Job No. 198337

Re: Response to Review Comments
PUDSP255 Antelope Ridge at Bull Hill, Phase 1
Bradley Rd
El Paso County, Colorado

Re: Addendum to Soils and Geology Study
PUDSP255 Antelope Ridge at Bull Hill, Phase I
El Paso County, Colorado
PCD File No. PUDSP255

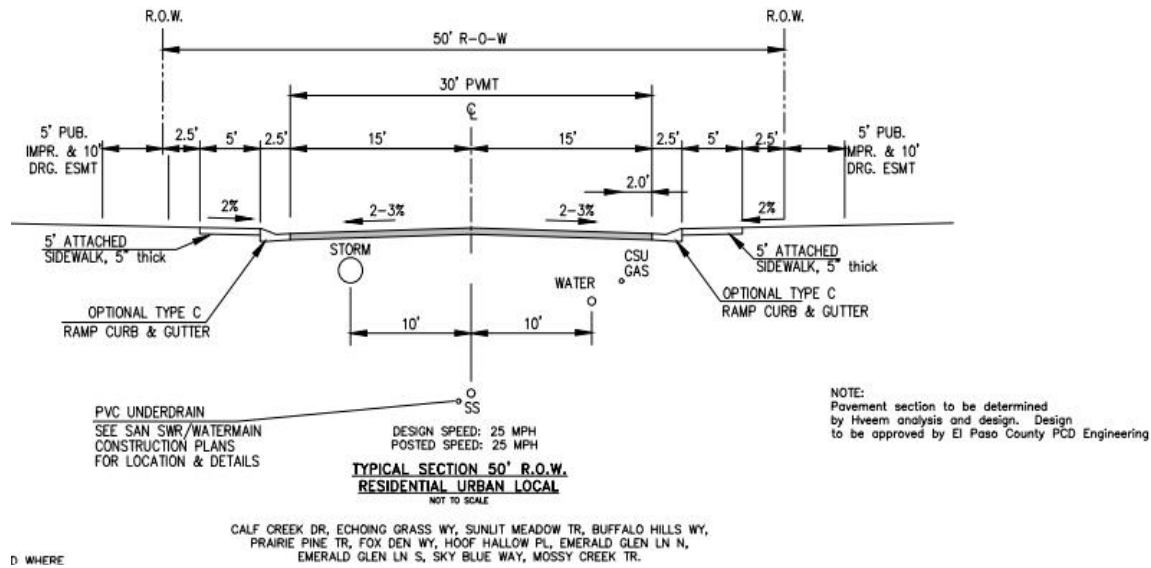
Provide a map showing geologic hazards & constraints.

Figure 11, Engineering and Geology Map was included in our report last dated March 14, 2025 and shown below. It is uncertain if the Figure was missed or insufficient. If insufficient we would request further explanation as to what is needed.

TEST BORING LOCATION PLAN

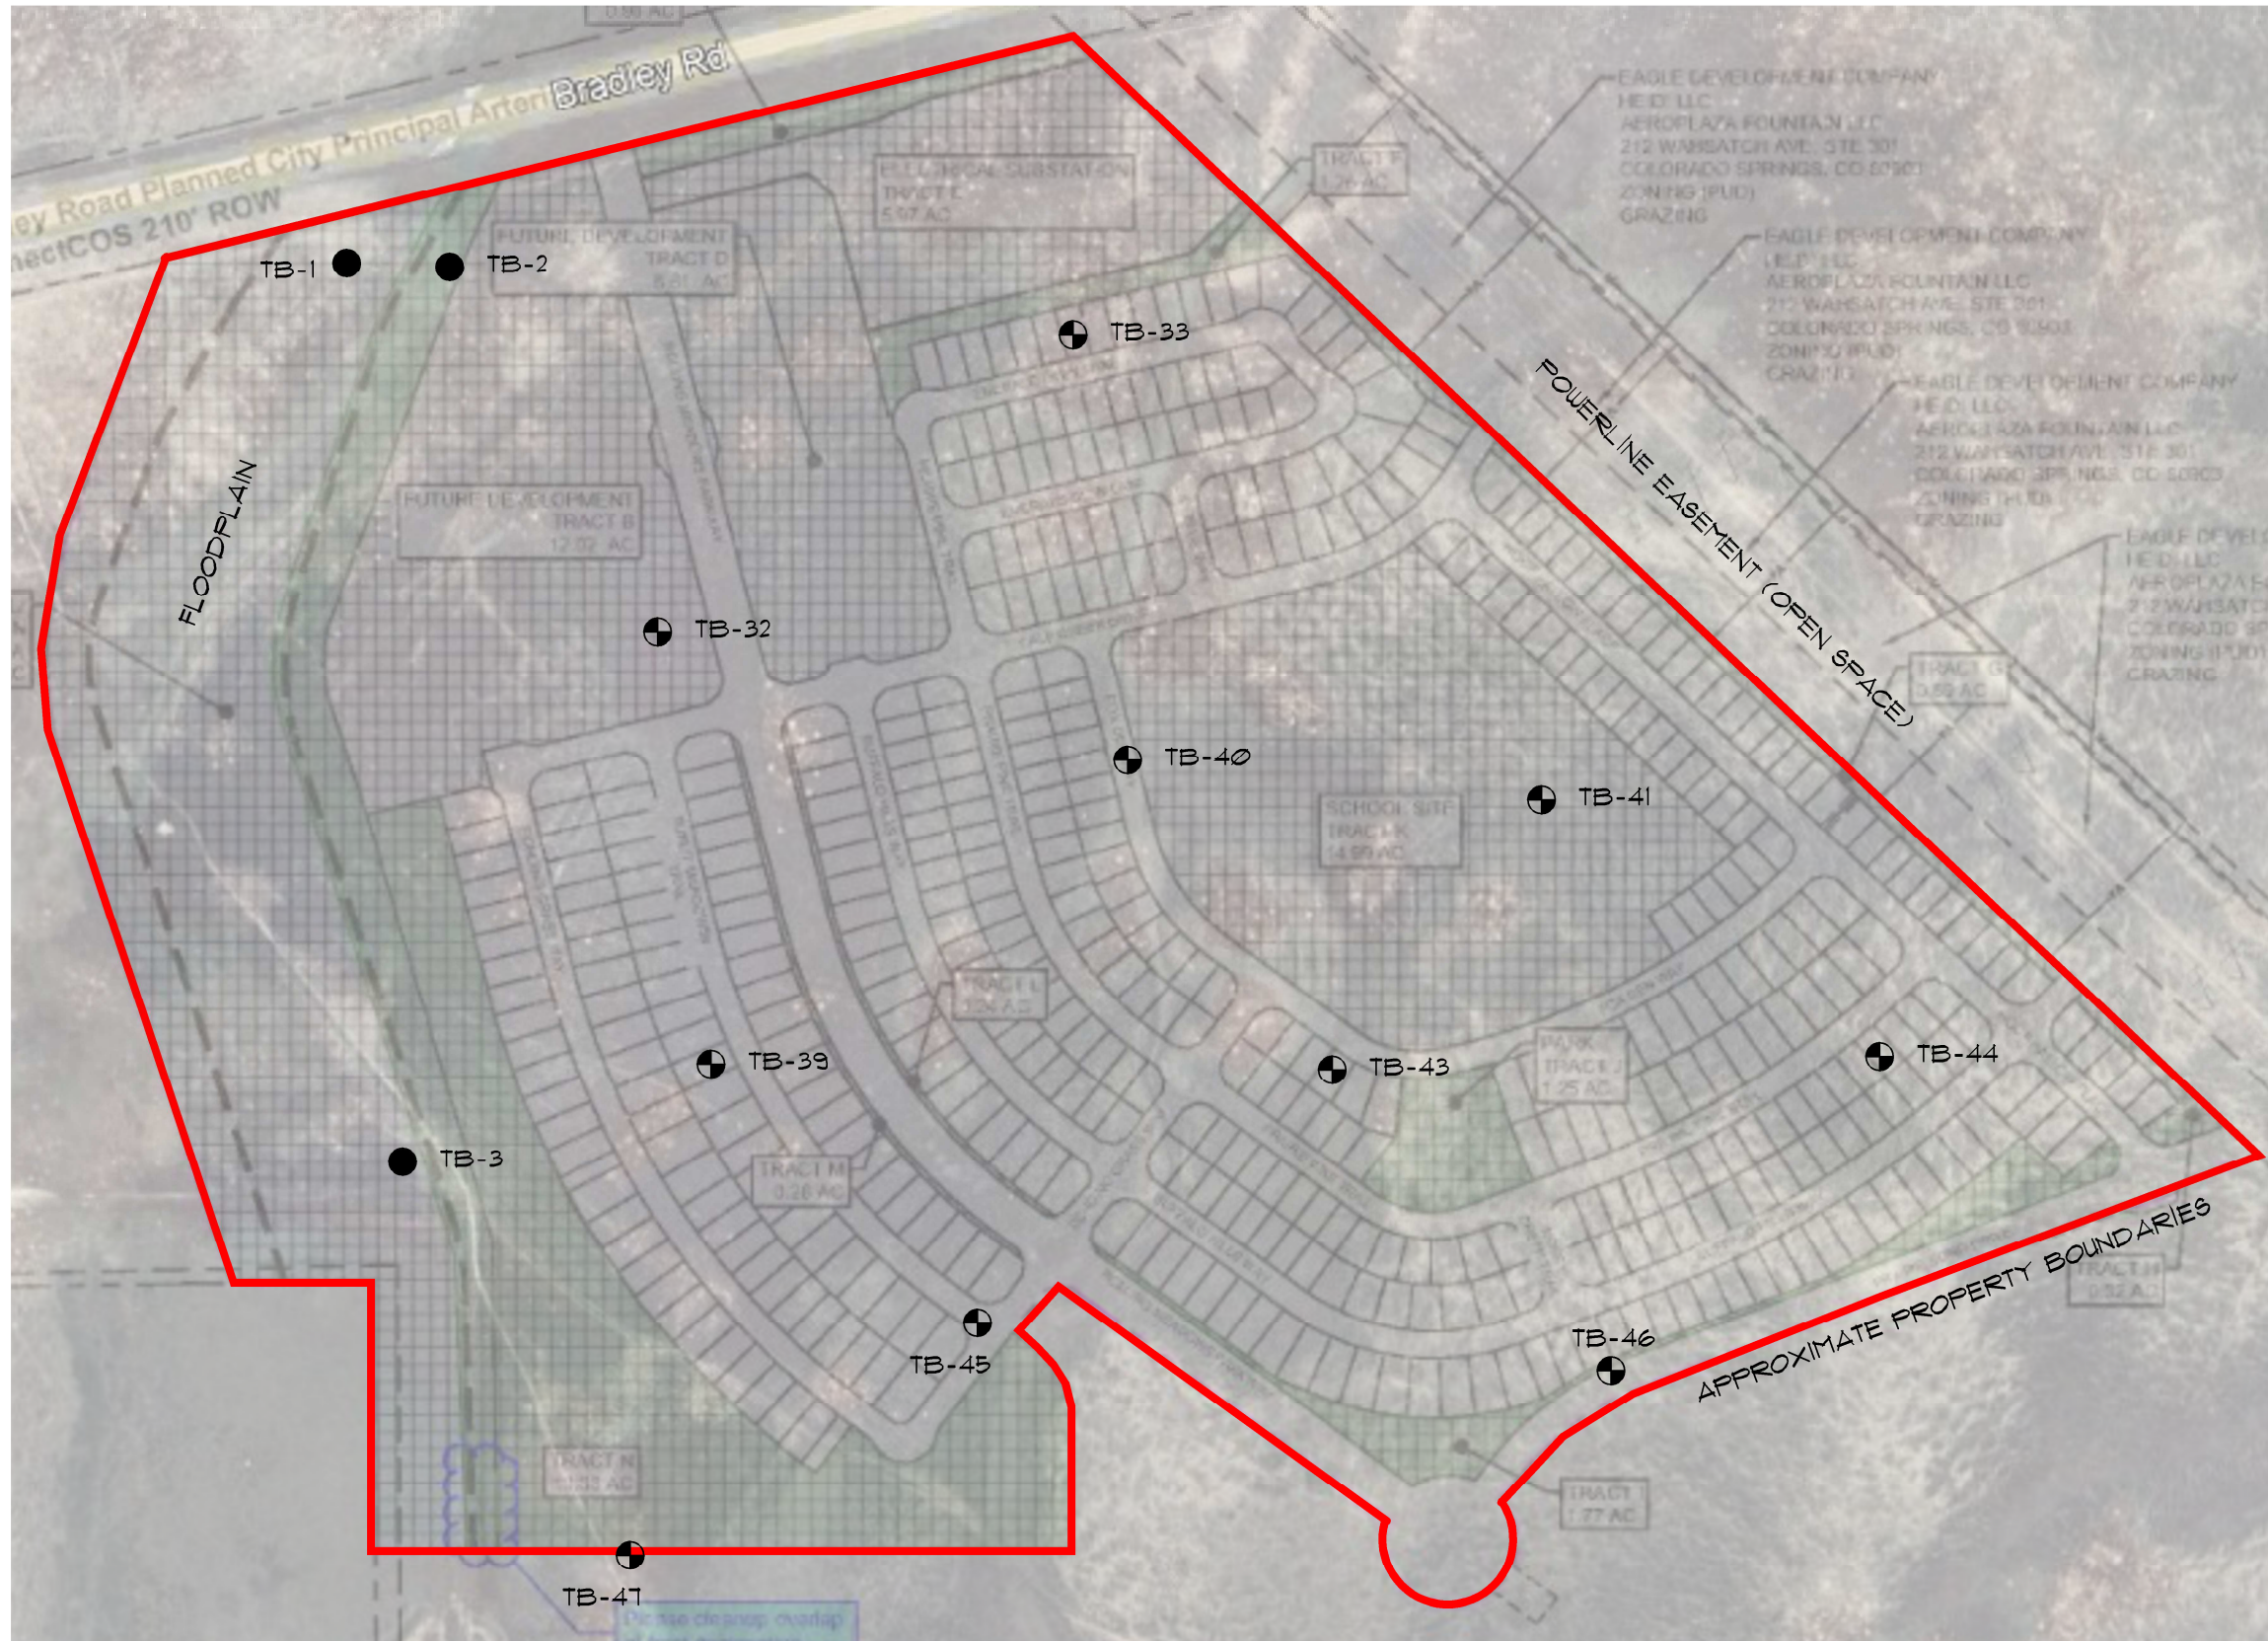
Please provide a clear figure showing all three test borings. If TB-2 is near the proposed pond, that could indicate potential for groundwater flow into the pond which would require mitigation. It is hard to tell without a figure that is clear where the borings are and the potential for this impact.

The amended report dated December 5, 2025 has been updated to reflect the additional requests. As for the comment on the location of TB-2, it is not located within a proposed pond per the Planned Unit Development provided by Matrix, last dated August 2025. TB-2 was located near Jimmy Camp Creek within the floodplain in Tract B designated for future development. A clearer Test Boring Location Plan, Figure 2 is included in the amended report.
